## COMMENT 1 – A LACK OF PUBLIC PARTICIPATION DURING THE EIA STUDY AS REQUIRED BY THE LAW

The Environmental Impact Assessment Study Report (“**EIA Report**” or “**ESIA Report**”) submitted by Amu Power Company Limited (“**APCL**”) to NEMA, a number of meetings were held with various stakeholders in Lamu during the first half of 2015.<sup>3</sup> The minutes annexed to the EIA Report indicate that the meetings served as an opportunity for APCL to share basic information about the project. According to the APCL, the last meeting took place on the 25<sup>th</sup> of June 2015 on Pate Island. Thereafter, and in accordance with Section 58 of the Environmental Management and Coordination (Amendment) Act, 2015<sup>4</sup> (“**EMCA**”) APCL submitted their EPR to NEMA for approval in September 2015. Nothing in the EIA indicates that any meetings took place after June 25<sup>th</sup> 2015.

## **COMMENT 3 – EFFECTS OF THERMAL EFFLUENT DISCHARGE AND ON THE MARINE ENVIRONMENT AND CRITICISM OF THE COOLING SYSTEM TECHNOLOGY**

Figure 16. Levelized Generation-Weighted Average PPA Prices by Contract Vintage

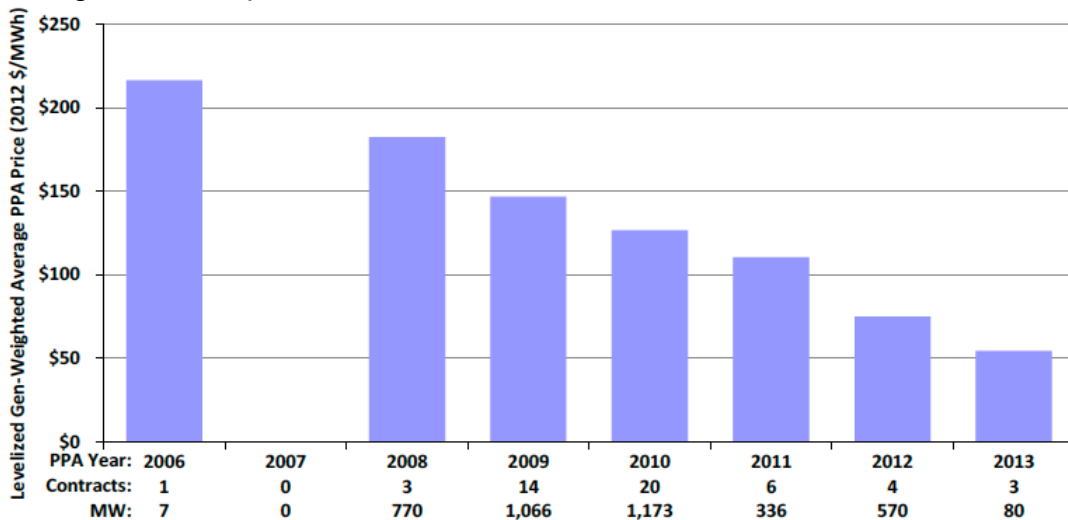
A levelized cost of electricity of \$50-60/MWh (5-6 cents/KWh) from utility-scale solar is **20-33% lower than** the levelized cost of electricity the proposed coal fired power plant in Lamu as claimed in the EIA. Additional technological advances will further reduce the levelized cost of electricity from utility-scale solar (and wind) in a manner that is not possible with coal, considering that it is a mature (outdated) technology.
